City of Pearl, MS
Southeast Sanitary Sewer Improvements (Airport Road)
Pickering Firm, Inc. Project 26917.00

DATE: Monday, 15 November 2024

ADDENDUM #1

SHEET NUMBER:
C5.01
 DESCRIPTION:
 ALTERNATE 1
 PLAN & PROFILE

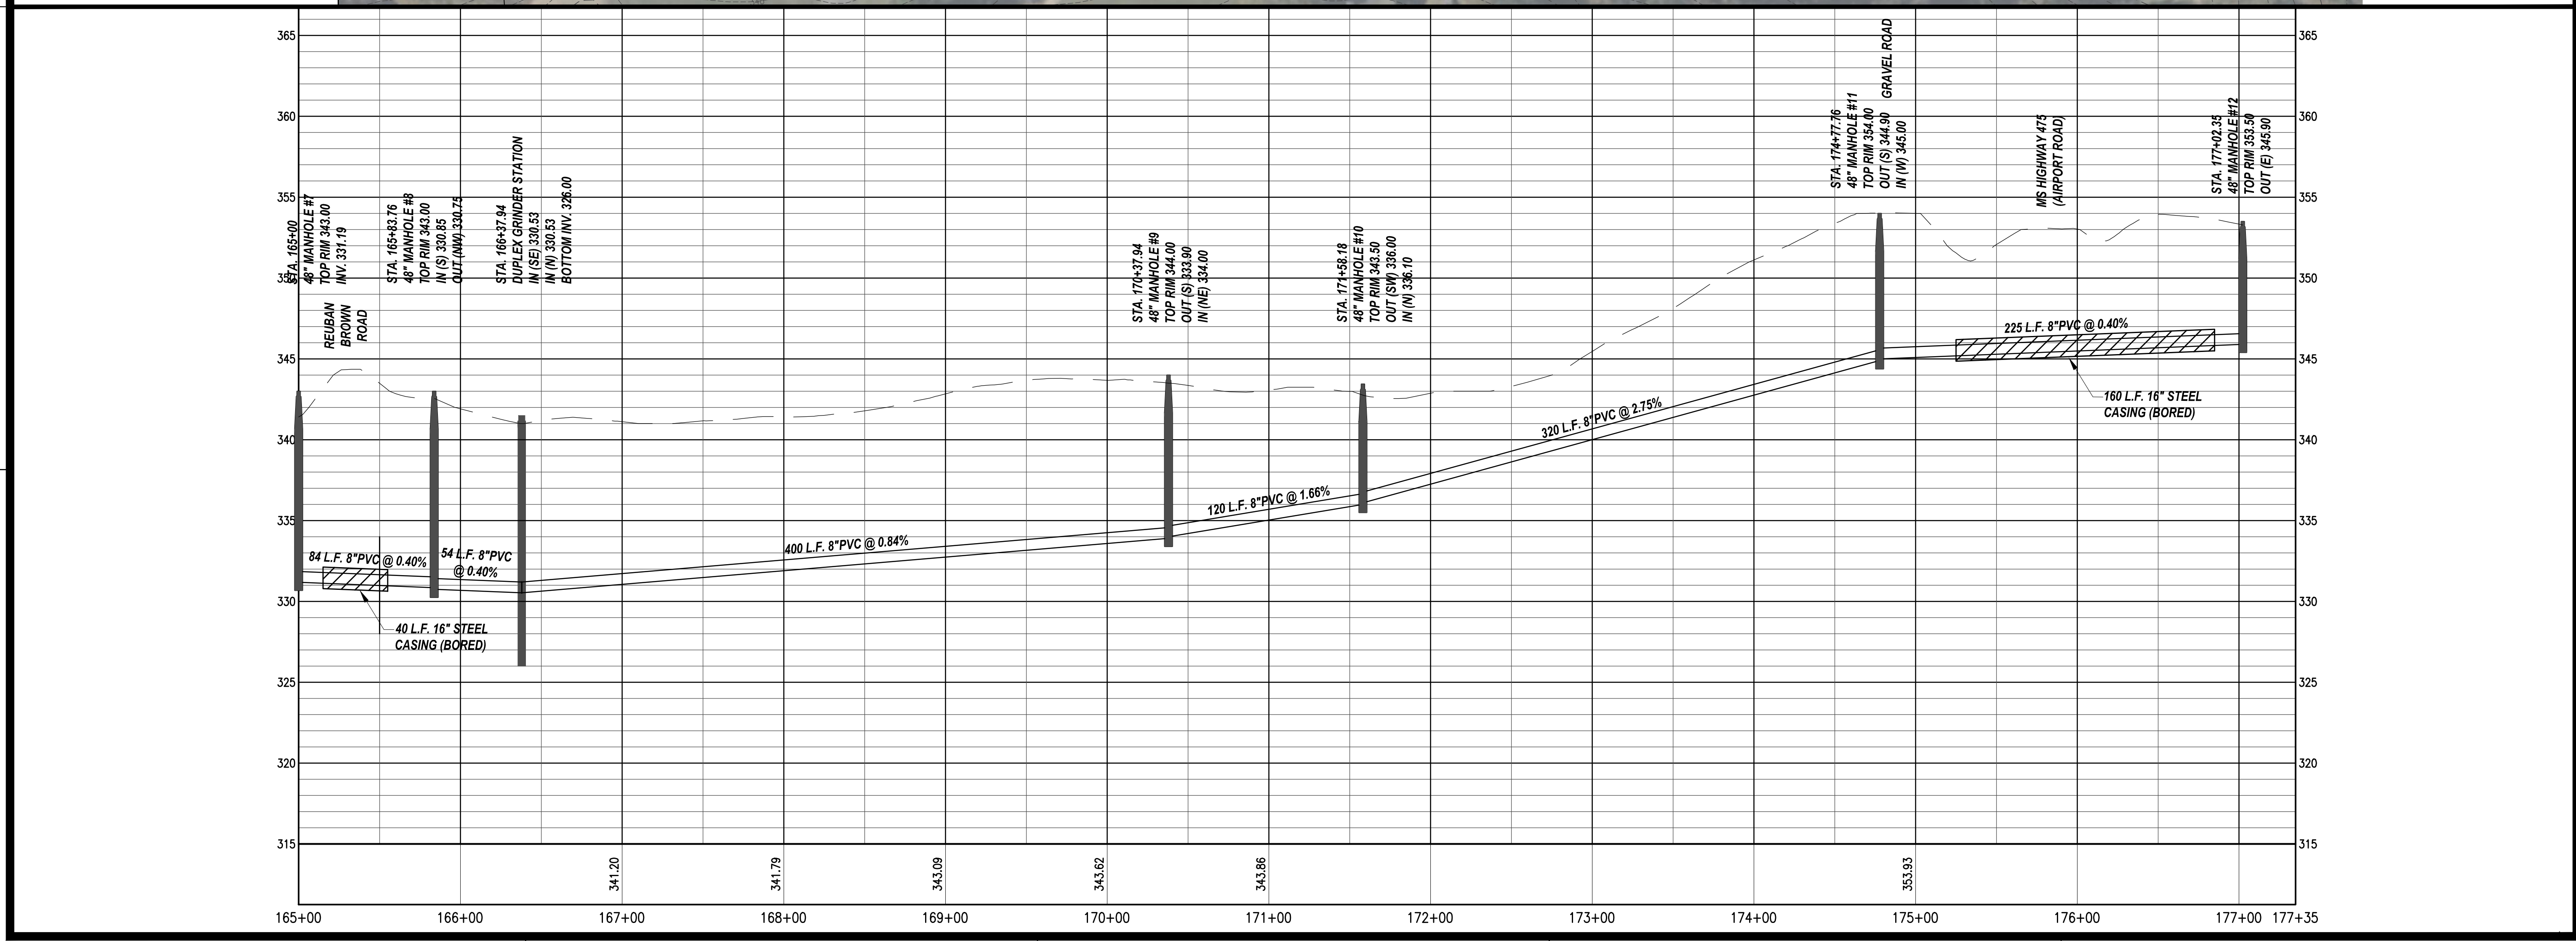
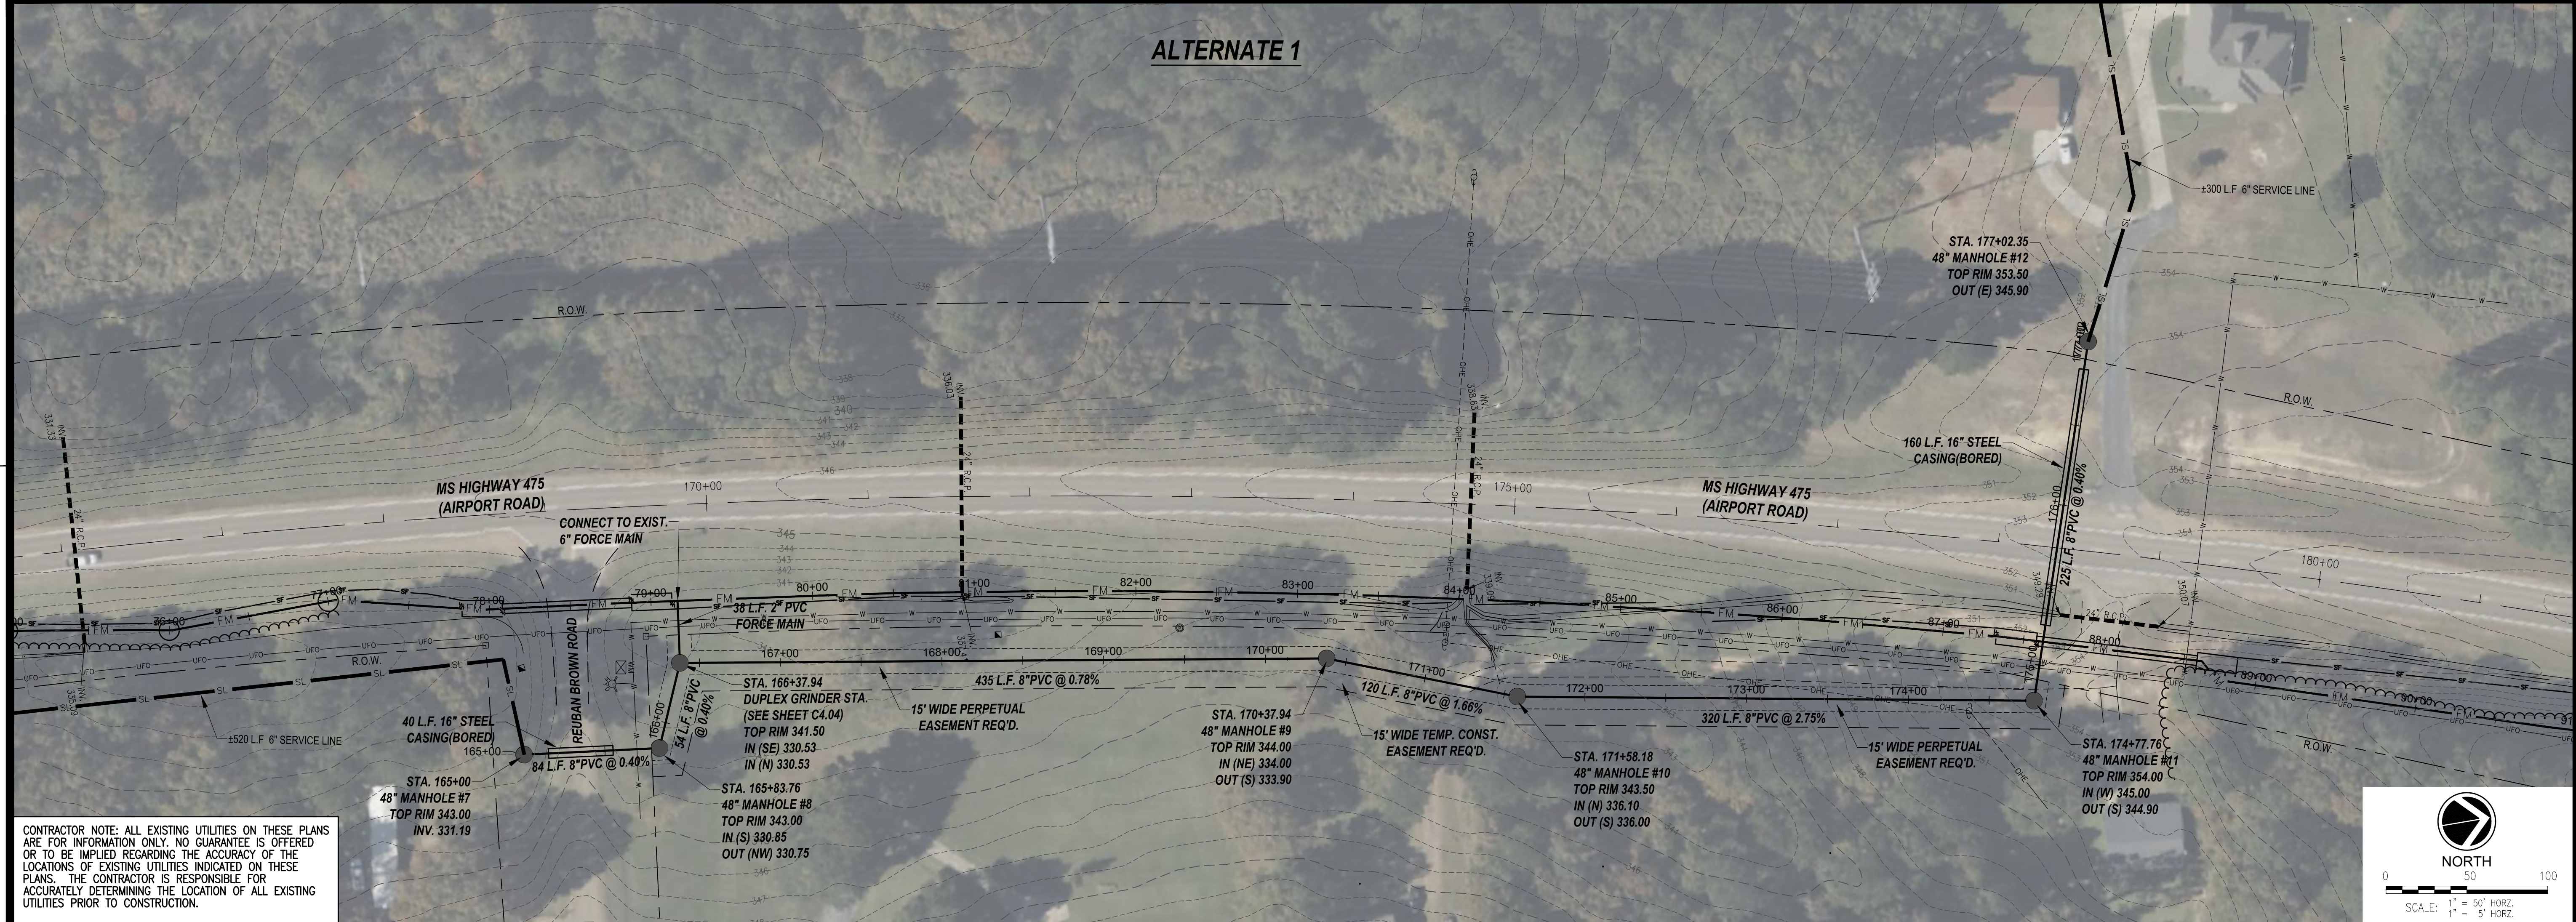
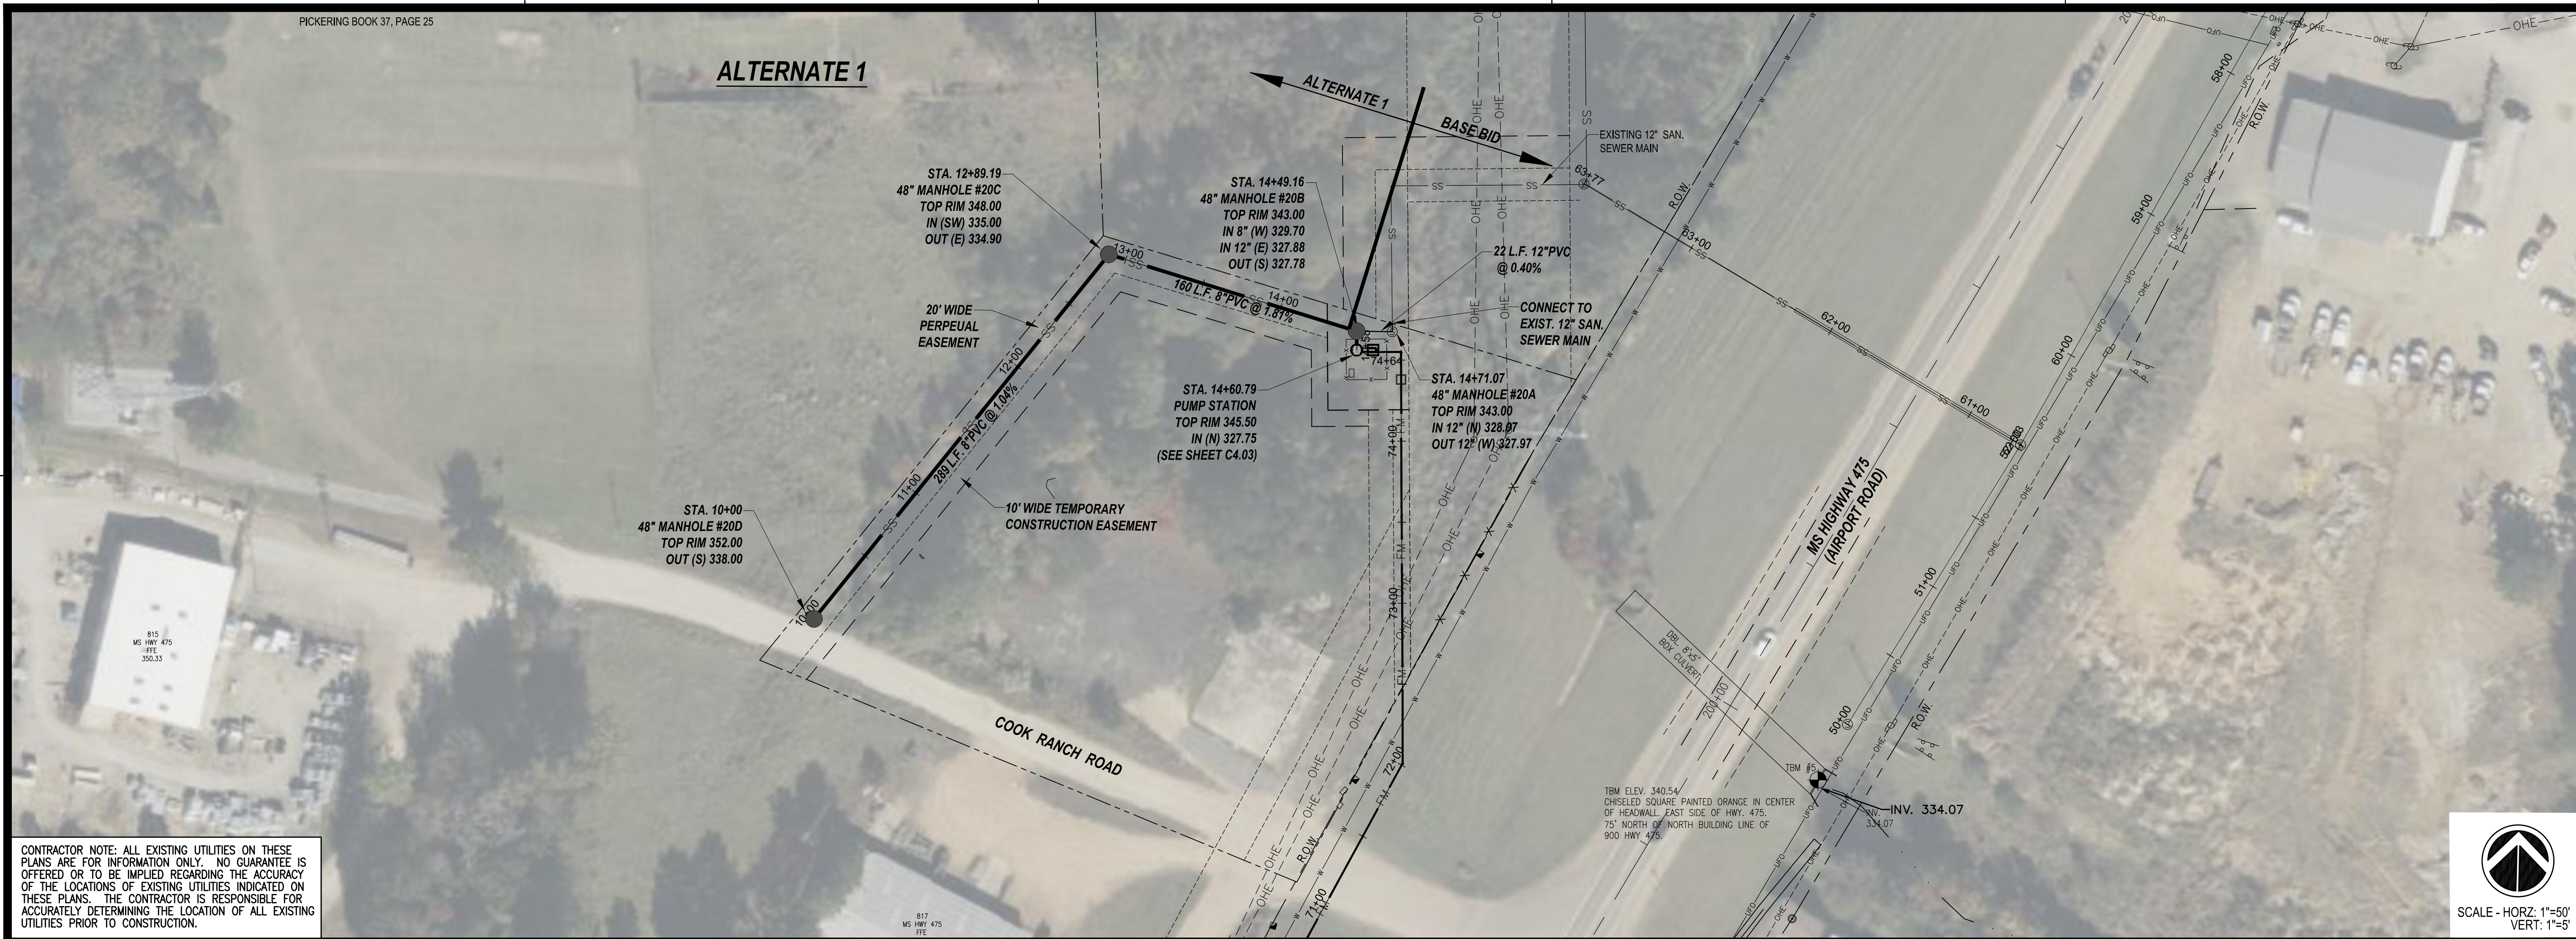
Added Plan Sheet C5.01; gravity sewer plan/profile Hwy 475/Reuben Brown Rd

SHEET NUMBER:
C5.02

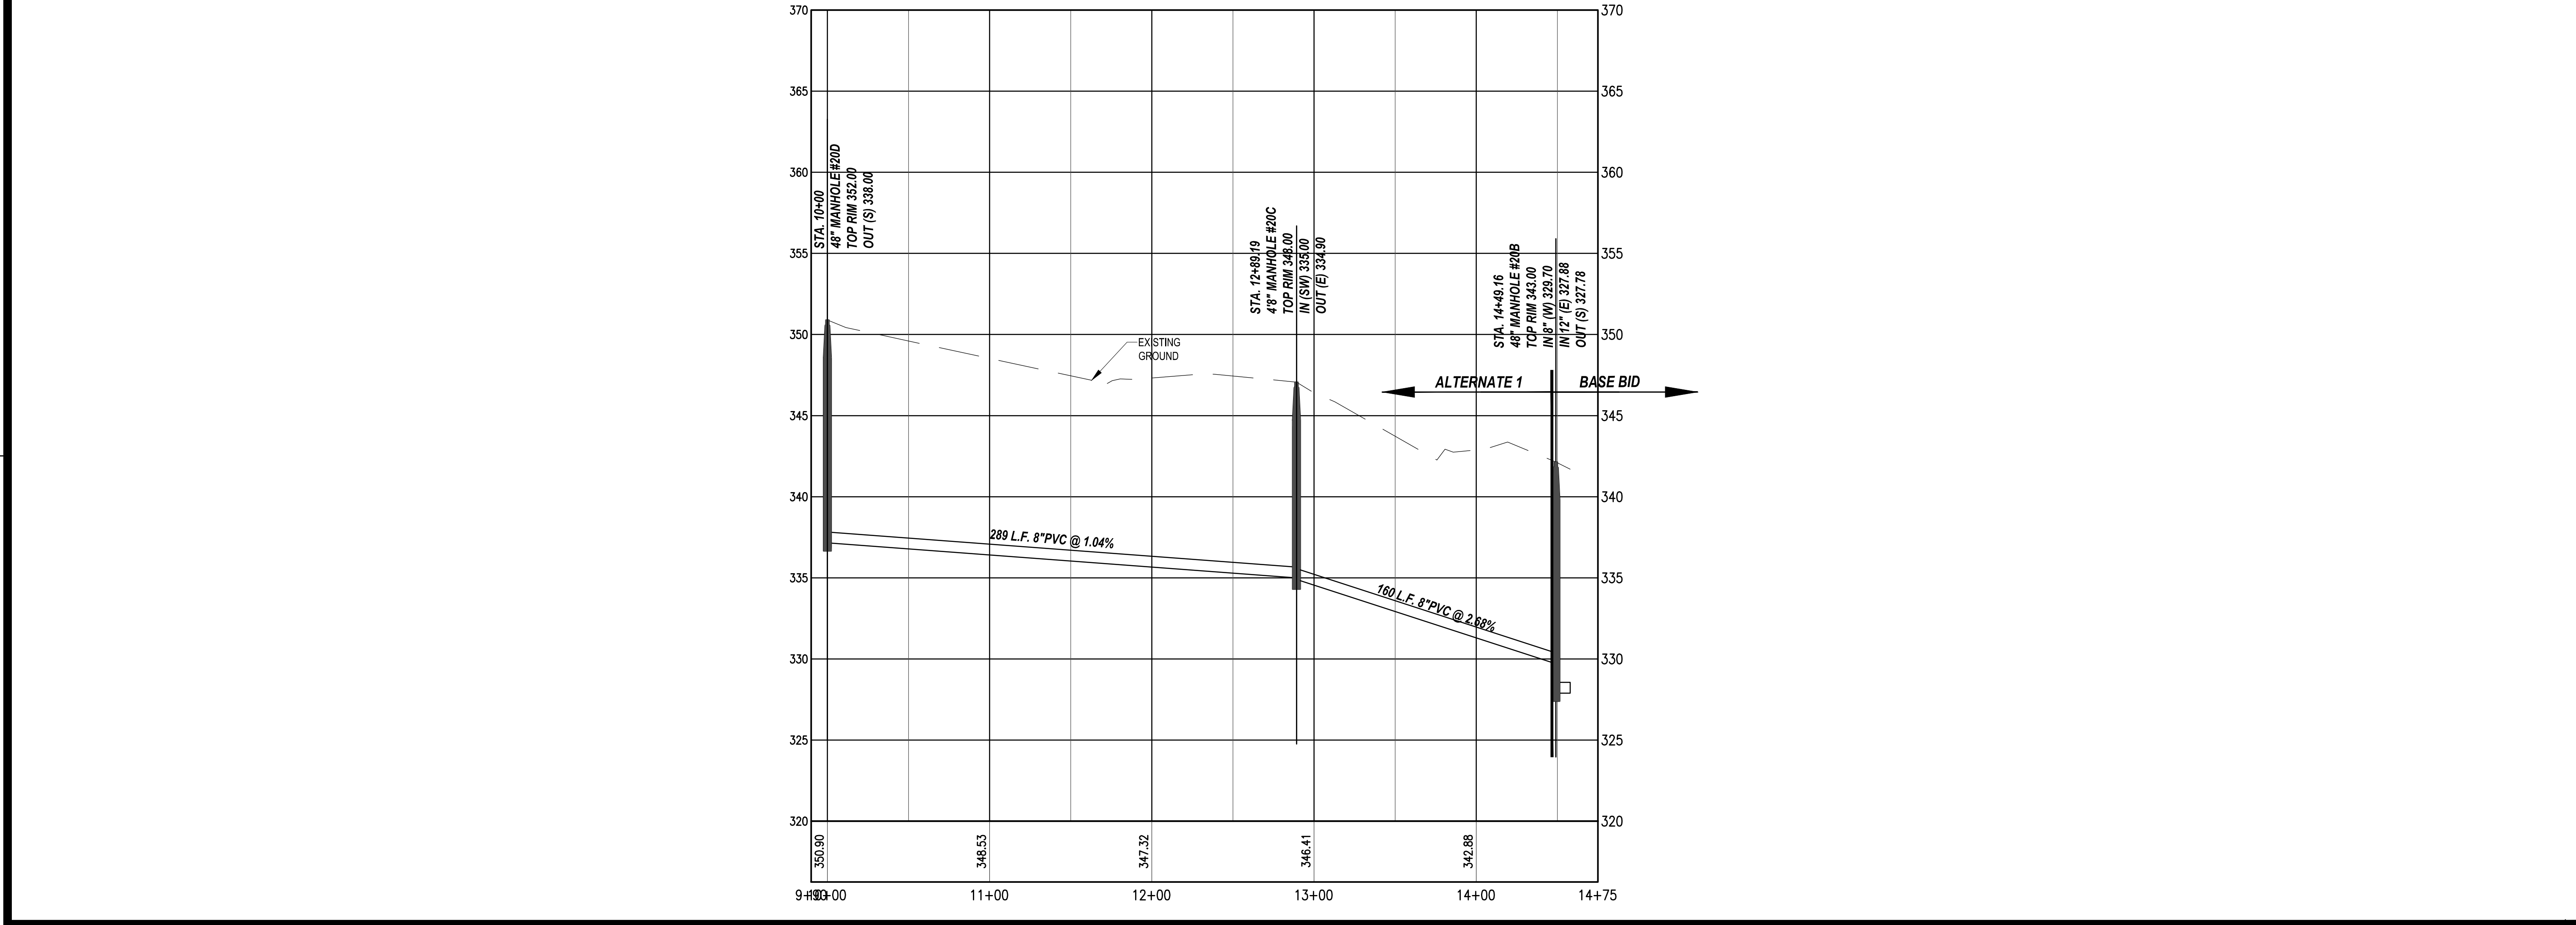
Added Plan Sheet C5.02; gravity sewer plan/profile lift station property
